**L-612 STUDENT SERVICES CENTER REMODEL COLLEGE COMPLEX**  
 BID DOCUMENTS

drawing title:  
**SS3 LOWER LEVEL DEMO PLAN - MECHANICAL**

M-0.1	MECHANICAL SYMBOL LIST & GENERAL NOTES
M-0.2	TITLE 24 - ENERGY COMPLIANCE FORMS
M-0.3	TITLE 24 - ENERGY COMPLIANCE FORMS
M-0.4	TITLE 24 - ENERGY COMPLIANCE FORMS
M-0.5	TITLE 24 - ENERGY COMPLIANCE FORMS
MD-1.1	SS3 LOWER LEVEL DEMO PLAN - MECHANICAL
MD-1.2	SS4 UPPER LEVEL DEMO PLAN - MECHANICAL
MD-1.3	ROOF DEMOLITION PLAN - MECHANICAL
M-2.1A	SS3 LOWER LEVEL FLOOR PLAN - HVAC DUCTWORK
M-2.1B	SS3 LOWER LVL. FLR PLAN - HVAC REHEAT PIPING
M-2.2A	SS4 UPPER LEVEL FLOOR PLAN - HVAC DUCTWORK
M-2.2B	SS4 UPPER LVL. FLR PLAN - HVAC REHEAT PIPING
M-2.3	ROOF PLAN - MECHANICAL
M-3.1	MECHANICAL DETAILS
M-3.2	MECHANICAL DETAILS
M-3.3	MECHANICAL DETAILS
M-4.1	MECHANICAL SCHEDULES
M-4.2	MECHANICAL SCHEDULES
M-5.1	HYDRONIC PIPING DIAGRAM
M-5.2	AIR FLOW DIAGRAM
M-6.1	MECHANICAL CONTROL DIAGRAM
M-6.2	MECHANICAL CONTROL DIAGRAM
M-6.3	MECHANICAL CONTROL DIAGRAM

drawing title:  
**SS3 LOWER LEVEL FLOOR PLAN - HVAC DUCTWORK**  
 drawing no:  
**M-2.1A**  
 drawing of

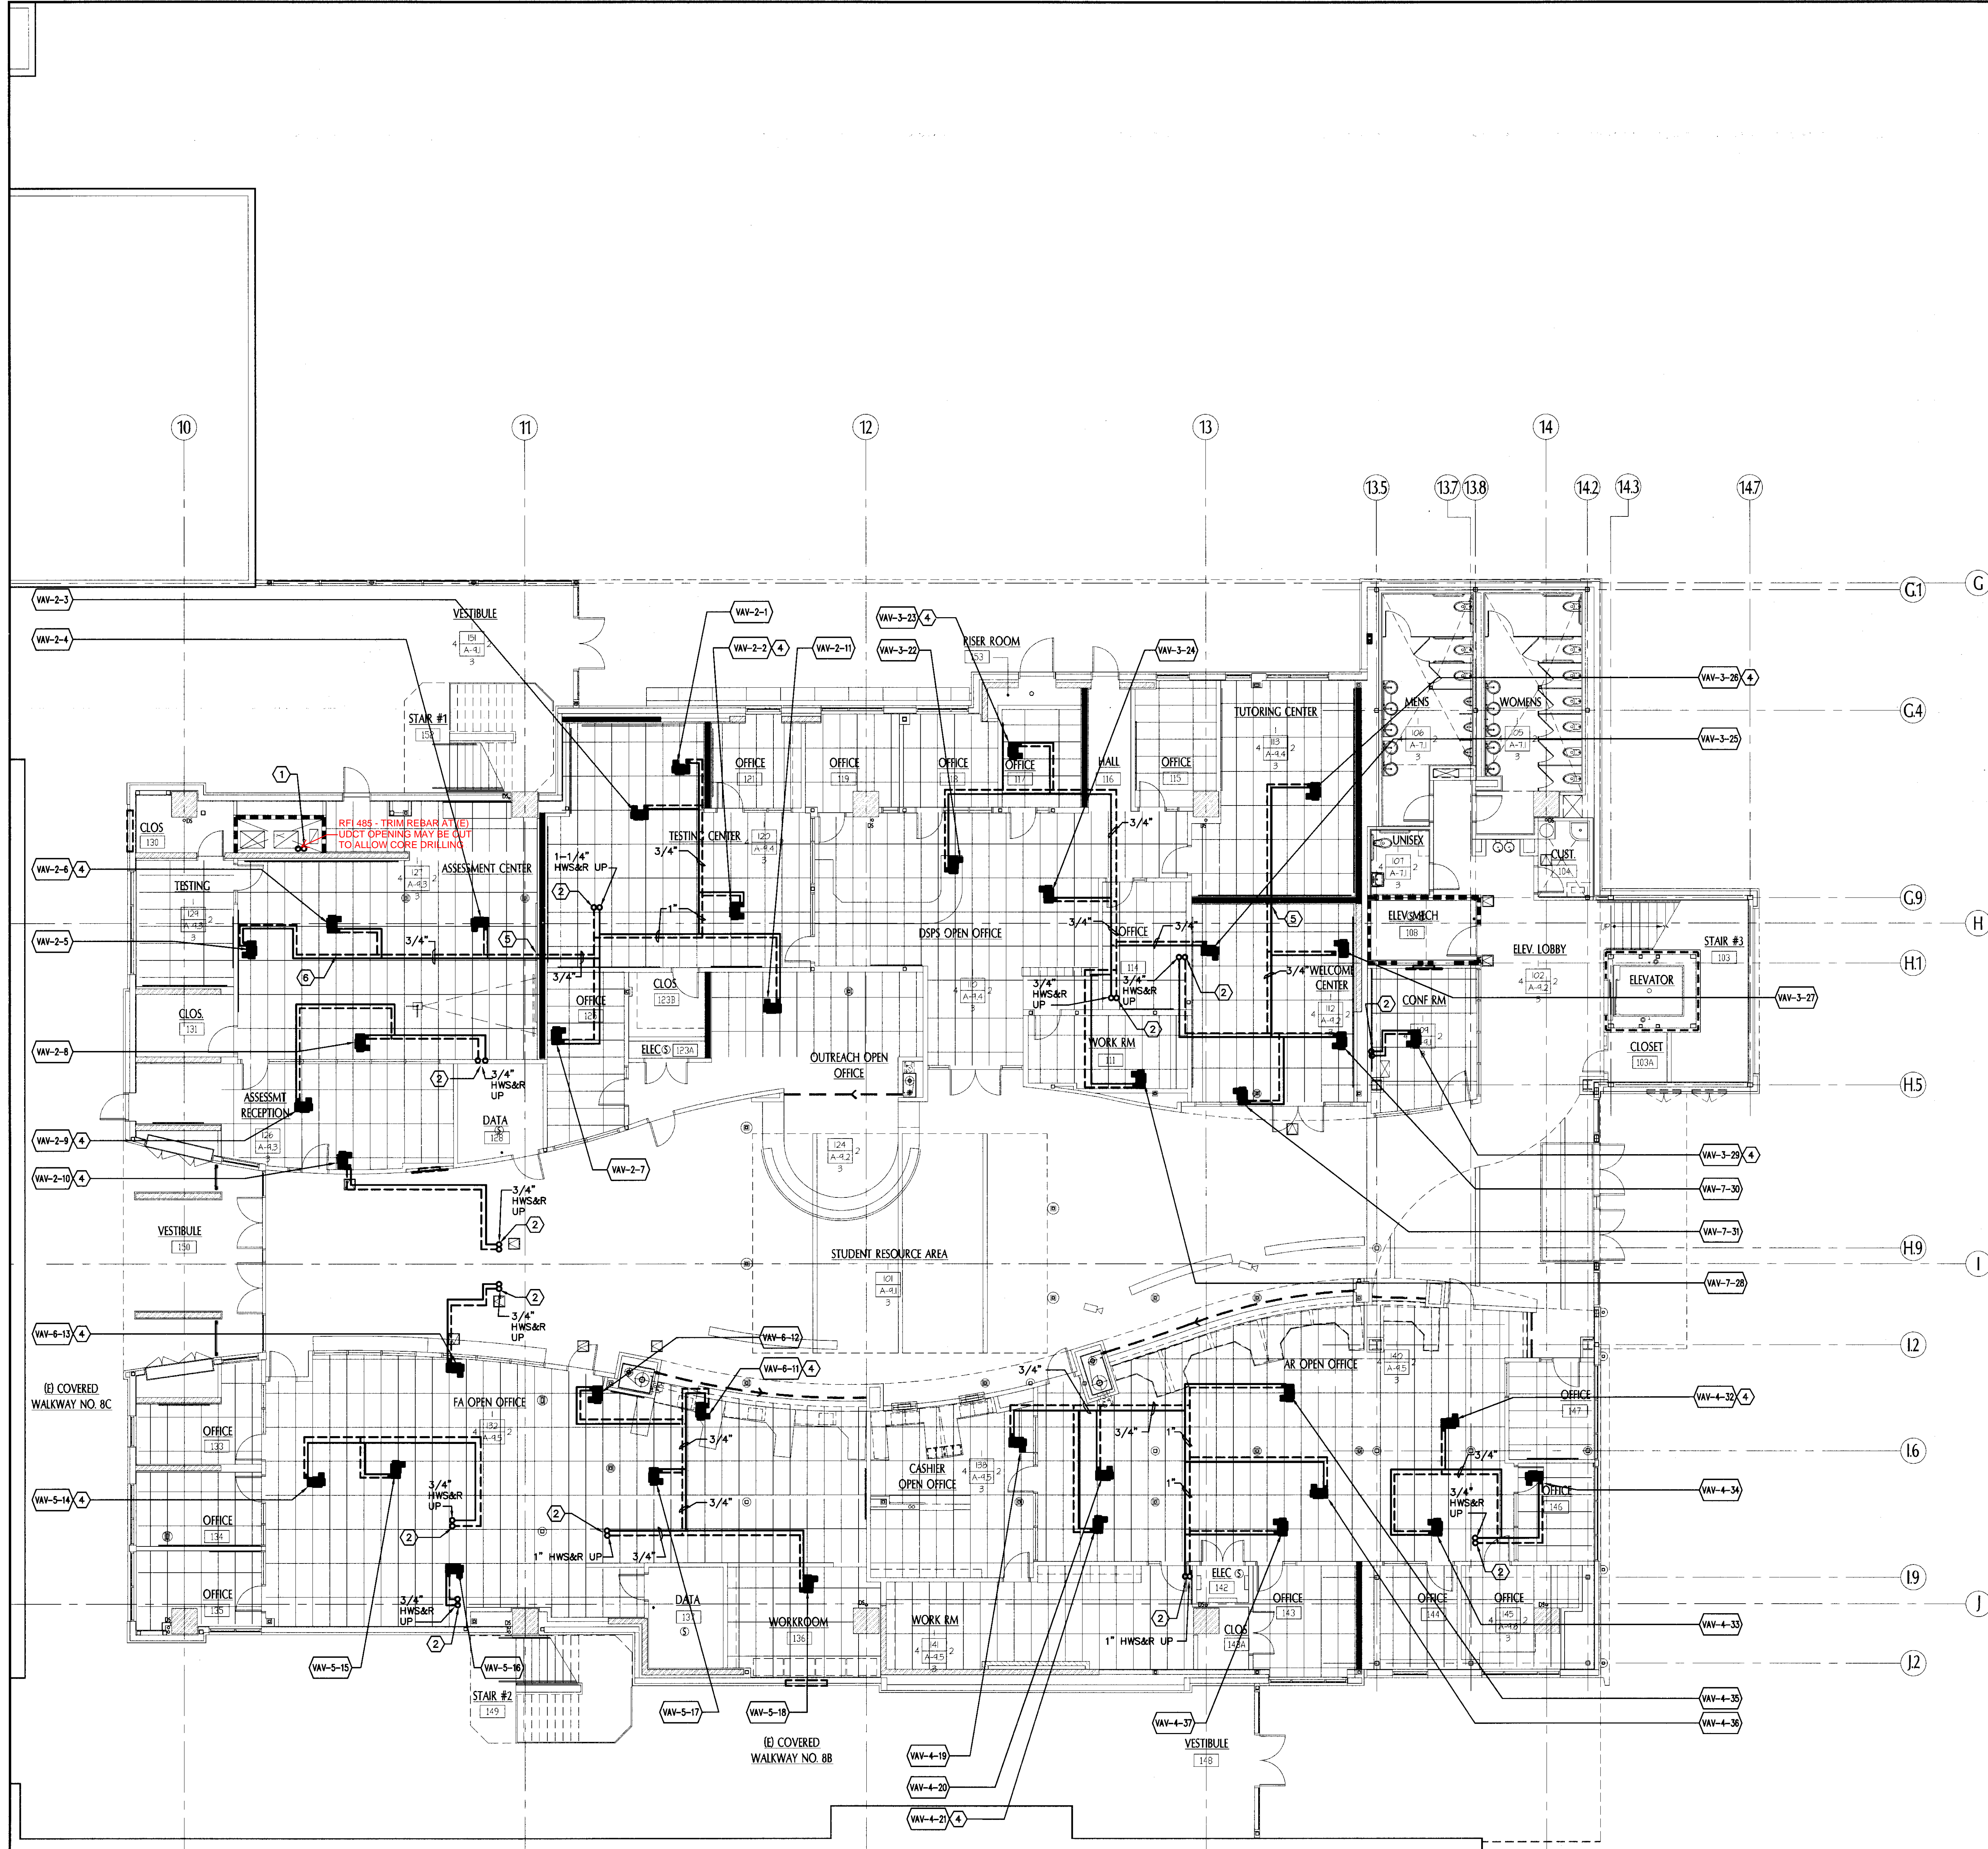
Space pressure sensor locations as indicated on sheet M2.1A.  
 - Utilize the sensor location on the west side of the building to control AHU 1, 2, 5, & 6.  
 - Utilize the sensor location on the east side of the building to control AHU 3, 4, & 7.

RFI 626 - AIRFLOW DISCREPANCIES (ROOM 231, VAV 2-2, VAV 2-32, VAV2-11, VAV 4-32, VAV 5-4)

drawing no:  
**M-2.2A**  
 drawing of

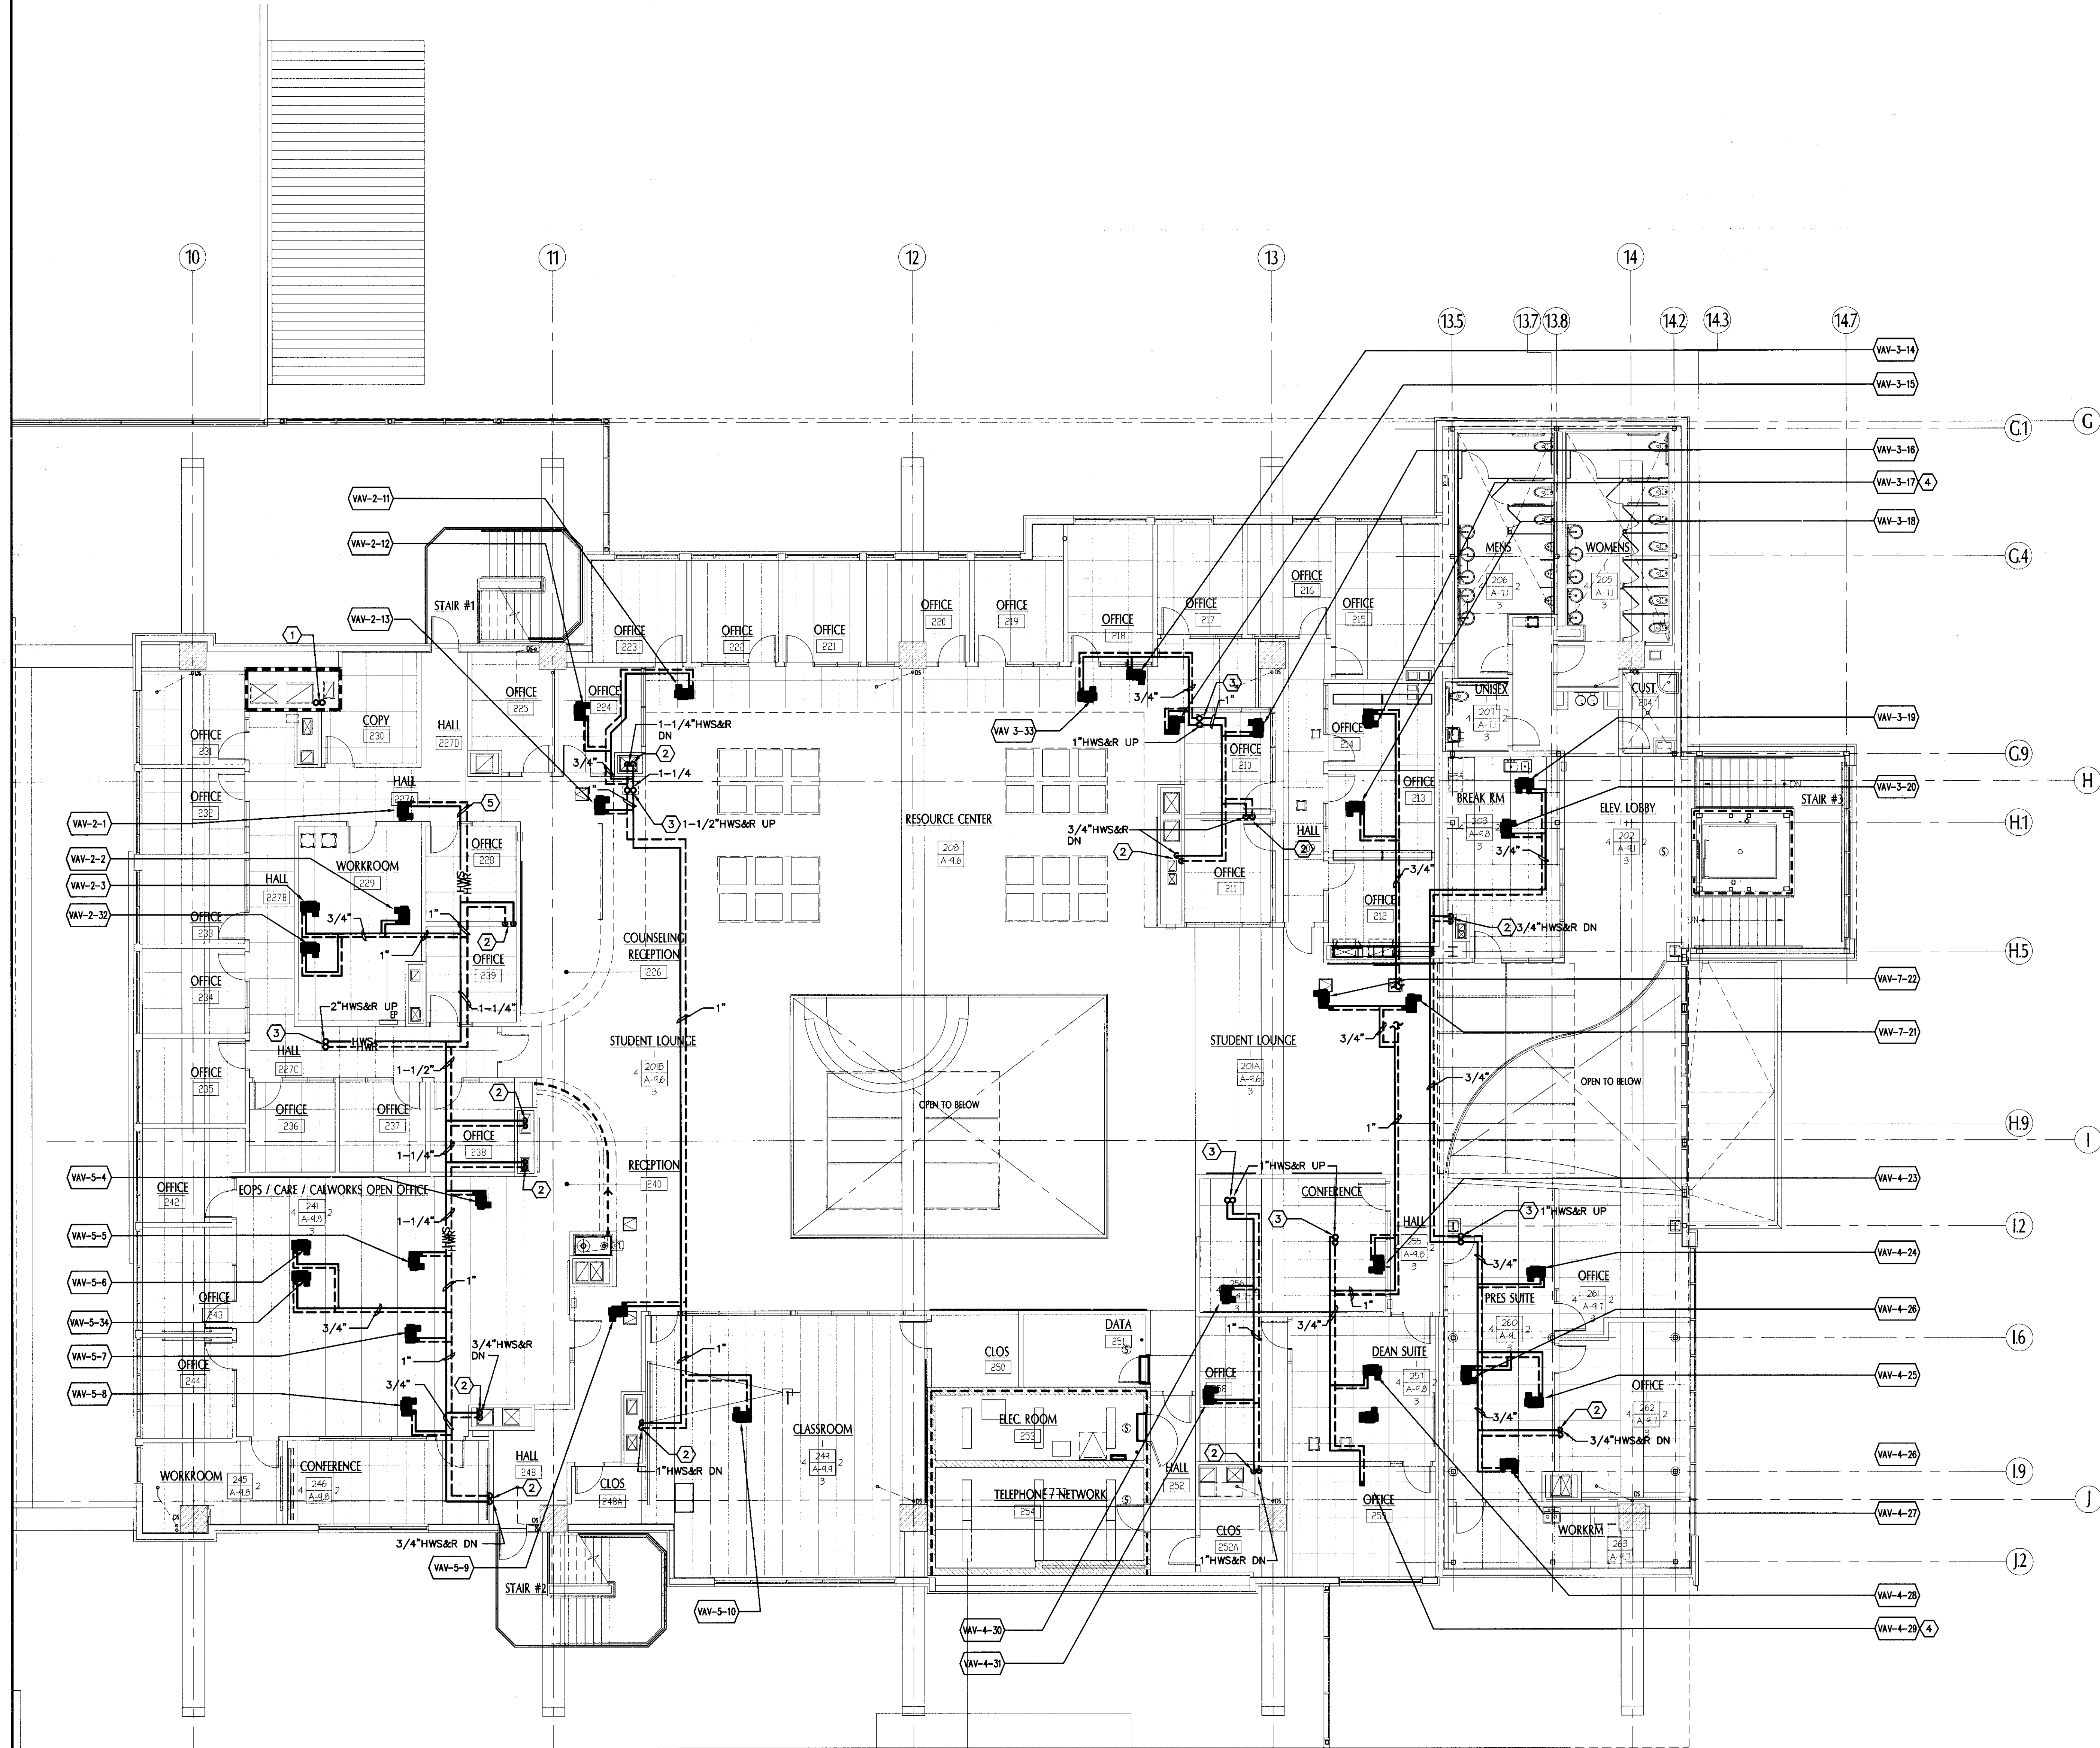
RFI 626 - AIRFLOW DISCREPANCIES (ROOM 231, VAV 2.2, VAV 2.32, VAV2-11, VAV 4-32, VAV 5-4)

**3 AHU SUPPORT CURB DETAIL**  
NO SCALE

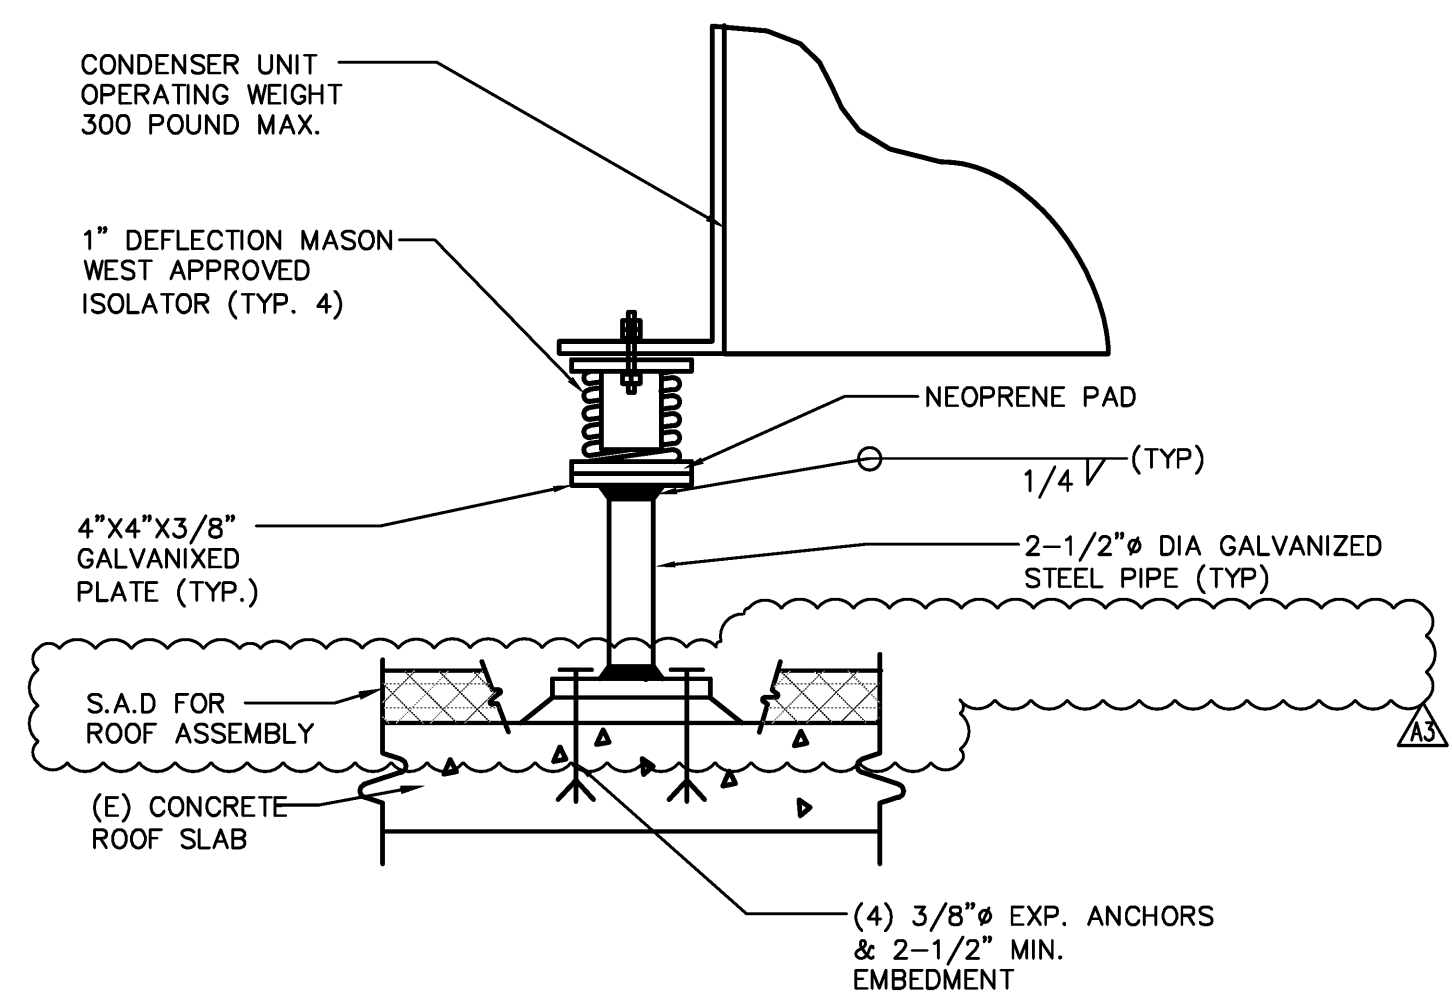
RFI 288 - IT IS ACCEPTABLE TO USE THIS DETAIL FOR THE SPLIT SYSTEM FOR THE MPOE AND 4-TON UNIT ON SUPPORT STANCHIONS
